- DESIGN CHANGES
1. Modular end links re-positioned slightly off existing buildings, with the party wall straightened and porch projections aligned with this wall, to ensure modular construction can be achieved off site.

Project	COUNTY FLATS, SANDFIELDS
Project number	N297
Client	HALE CONSTRUCTION LTD
Title	BLOCK 01/02 ELEVATIONS 2/2
Drawing number	A012
Scale	1 : 100 at A1
Revision	H
Status	INFORMATION
Drawn	PC
Date	30.11.21

01 S-02 Block 1 Courtyard Section
1 : 100

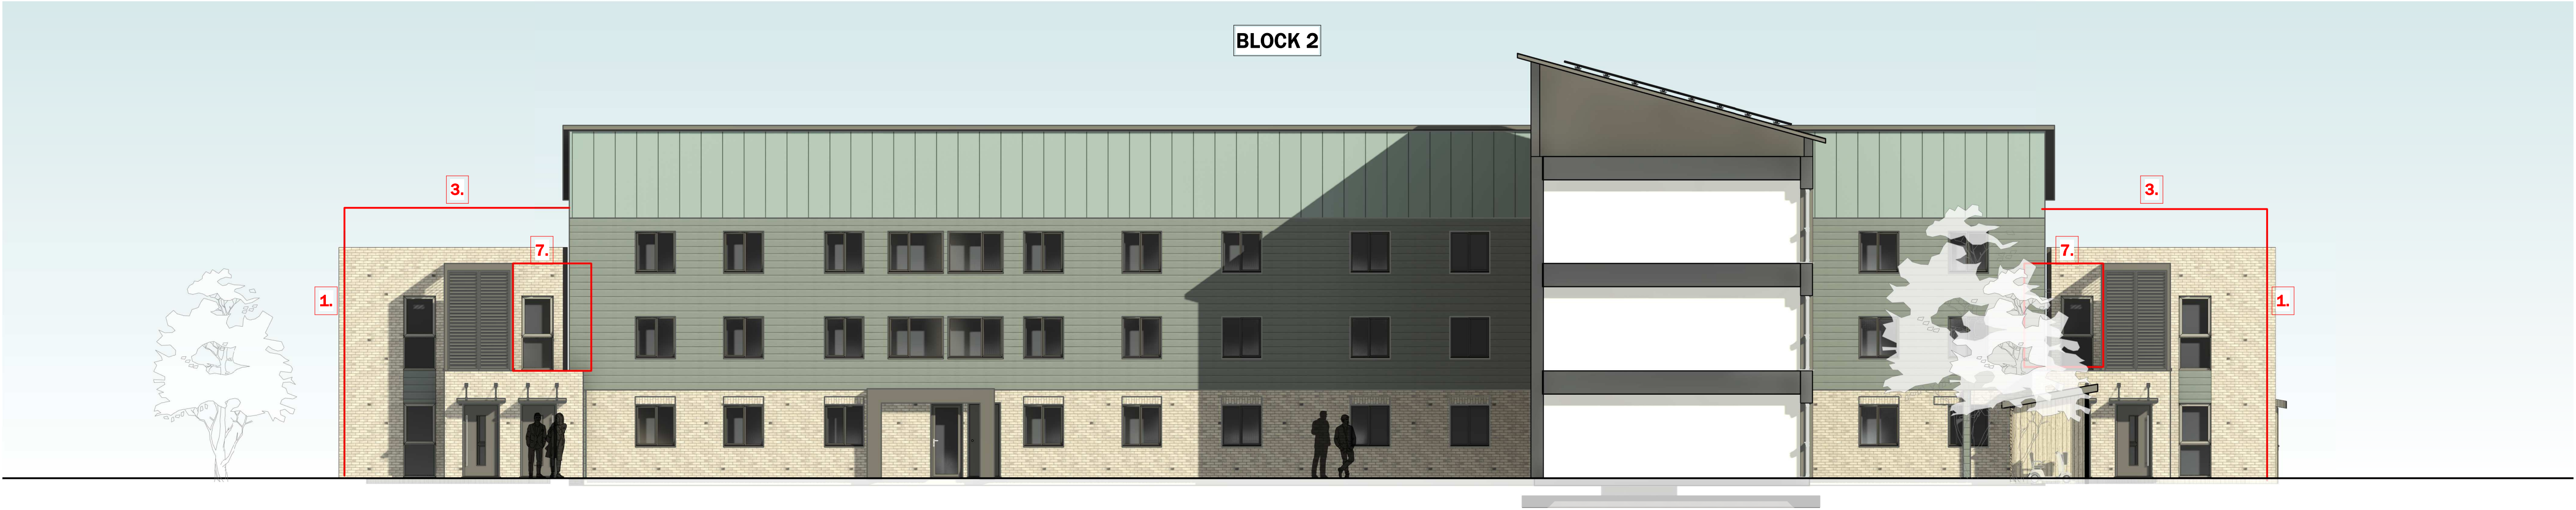
2. Windows have been slightly re-positioned to the new build to suit the structural design of the modular units and the constraints of the timber frame.

3. Parapet to modular end blocks have been lowered by approx 900mm to comply with the structural wind loadings and timber frame design.
 4. Corner windows have been removed and replaced with 2no. Windows on either corner, again due to the structural and timber frame design of the blocks.

5. PV panels have been omitted from the end modular units to suit the structural and timber frame design of the blocks.
 6. Ground floor Juliet balcony added to existing flats to provide better security whilst ensuring the open areas remain as communal spaces.

7. Air source heat pump external louvre enclosure amended to be single storey over entrance canopy to end link blocks.
 8. External air source louvered enclosure handed to provide internal riser/access requirements for maintenance.

9. Buggy/cycle store added to block 6 and 7 parking courtyards.
 10. Bin stores slightly re-positioned to suit existing drainage runs, with bin store near block 6 amended in size to suit located of bedroom window.

11. Footpaths amended to be Tarmac.
 12. Windows in communal area to the linked blocks made narrower to ensure 1.8m fire separation distance to existing windows is achieved to comply with building regulations.

13. 1no. window in block 7 communal area either side of stairwell removed to ensure 1.8m fire separation distance to existing windows is achieved to comply with building regulations.
